FW: Ventia-DQ-000361: Tamborine Mountain Road 205 E29 - 85% designs ACNXREF<ZFFIACYdlua5T23xNhoY4> [SEC=Internal] [SEC=INTERNAL]

Subject: Tamborine Mountain Road 205 E29 - 85% designs

Please find attached an 85% design submission for the E29 works on Tamborine Mountain Road 205 Ch 5.65 to 5.8km. We have reviewed it, refer the attached comments register. I have assigned some comments to TMR which need feedback. The main item would be Comment 11 in the register. It appears the chainages on the DVR/business case do not quite line with the centreline control line provided by ARMIS, so the extents on the drawings are different to the business case. However it should also be pointed out there is already asphalt within the extents so this might be causing the skid issues and might just need shot blasting to improve the surface

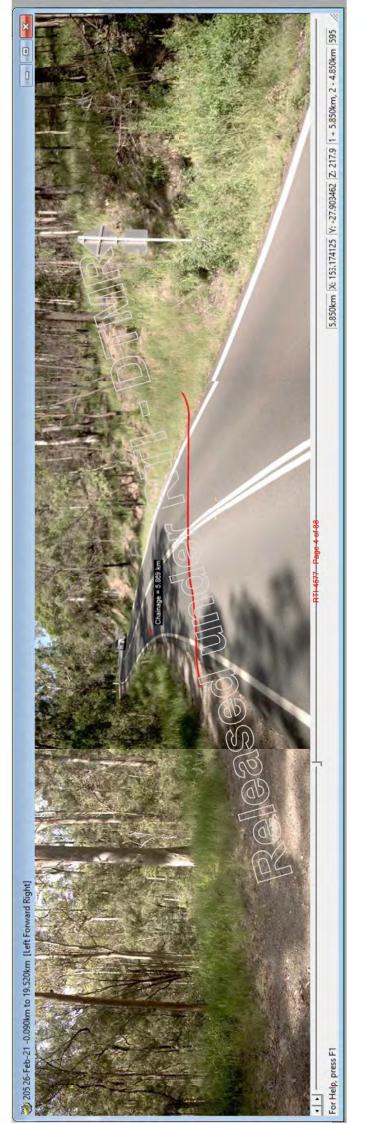
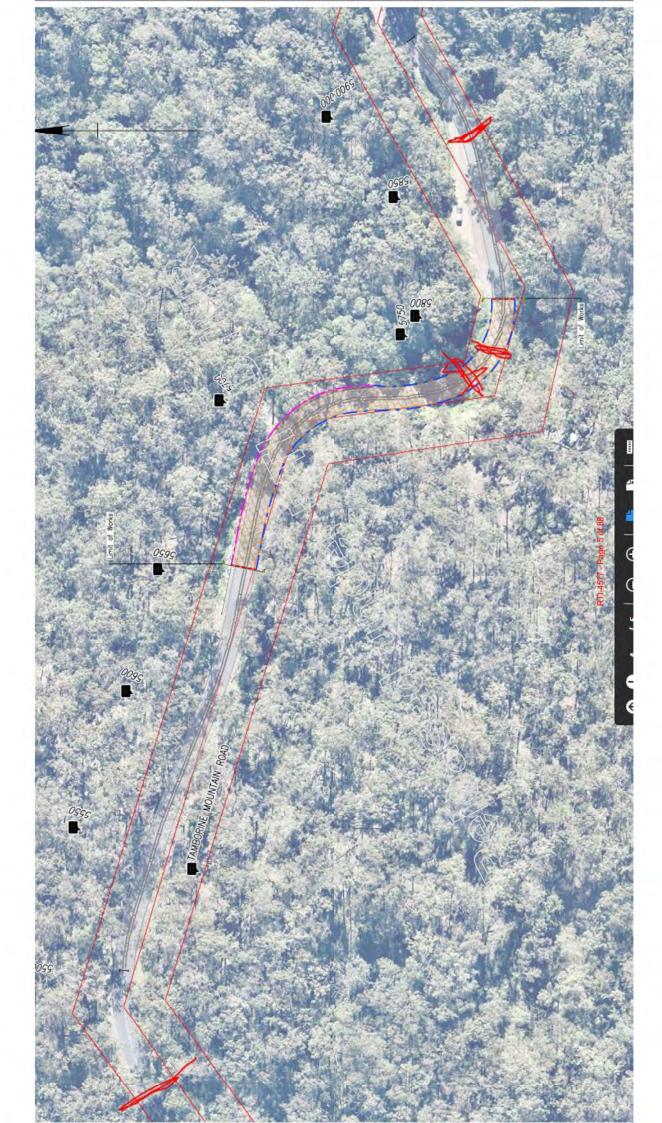
Just following up on the below emails to get all this on drawings correctly. The attached images are from DVR Feb-21 (there is a slight variation between the Feb-21 and the current Mar-22 DVR)

Shot blast the Asphalt section form chainage 5.860 – 5.760 (this will address the crash black spot)

DVR Feb-21 Ch 5.76 looks right DVR Feb-21 Ch 5.86 looks right

would likely be needed to confirm there's no issues with getting a new spray seal down on this bend. Spray seal Ch5.760 – 5.460 (given timeframes and budget this might not be able to happen this year, if it can that's great.)
A site visit with NR would likely be needed to confirm there's no issues with getting a new spray seal down on

DVR Feb-21 Ch 5.46 looks right

Attached is the plan view showing where these DVR sections line up. The chainages on the plans will be adjusted to suit the images attached, so I will arrange to have the drawings updated.
